Architectural Review Board

Staff Report (ID # 9376)

Summary Title: 375 Hamilton: Downtown Parking Garage (3rd Formal)

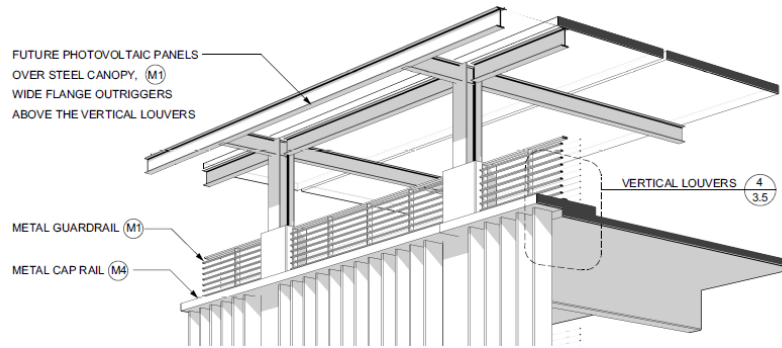
1. *Setback from 560 Waverley's window wall*: The ten foot setback facilitates construction, provides a path for underground utilities, allows for openings for natural ventilation into the

parking garage (thereby avoiding noise from a mechanical ventilation system above grade), and allows light to reach the existing windows.

The below image from the December 2017 plans, shows the earlier Hamilton Ave. elevation:

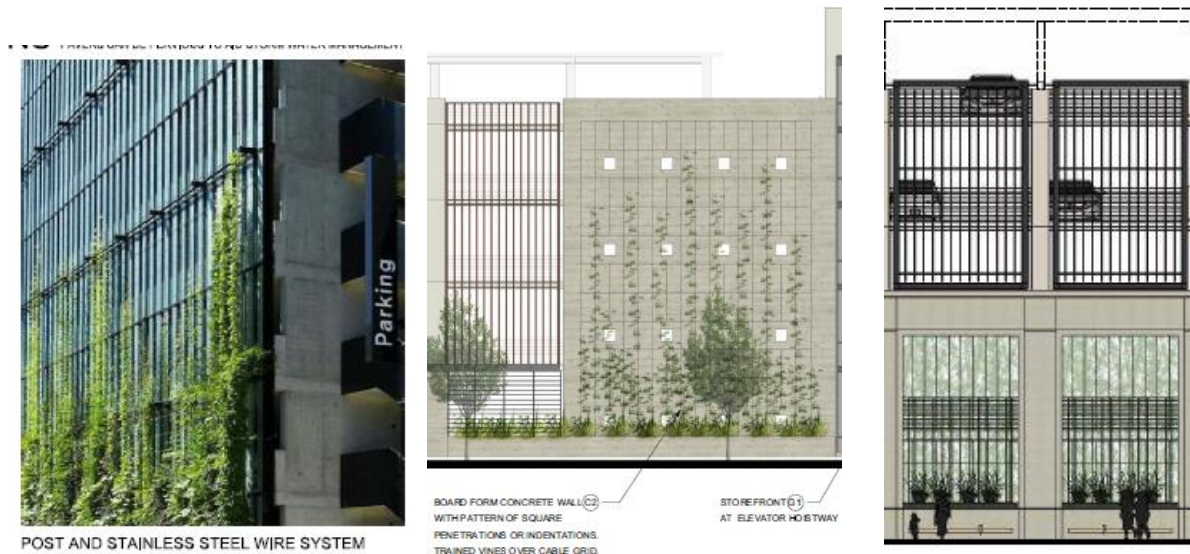
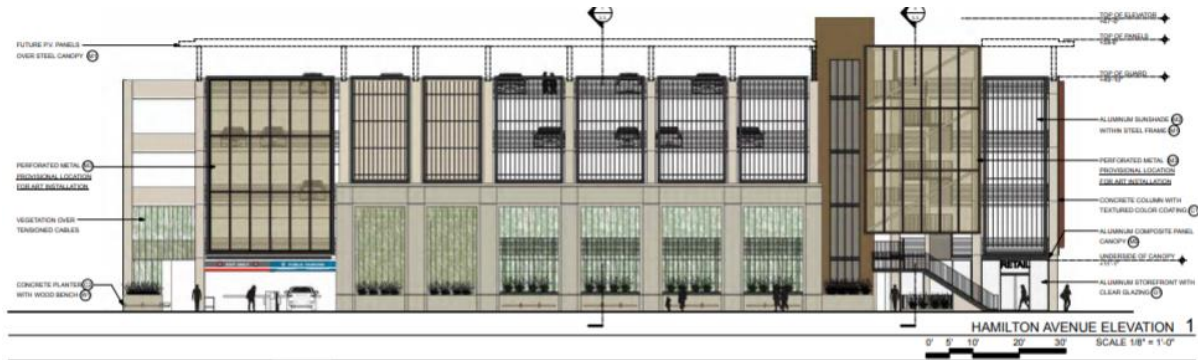
The images below show a post and wire system (left photo), excerpt of the Hamilton elevation (middle image) wired vines attached to board-formed concrete), and 2017 elevation excerpt.

Images of the Hamilton and Waverley elevations below allow visual comparison of December 2017 and May 2018 designs. The first elevation shows the revised Hamilton Ave. elevation.
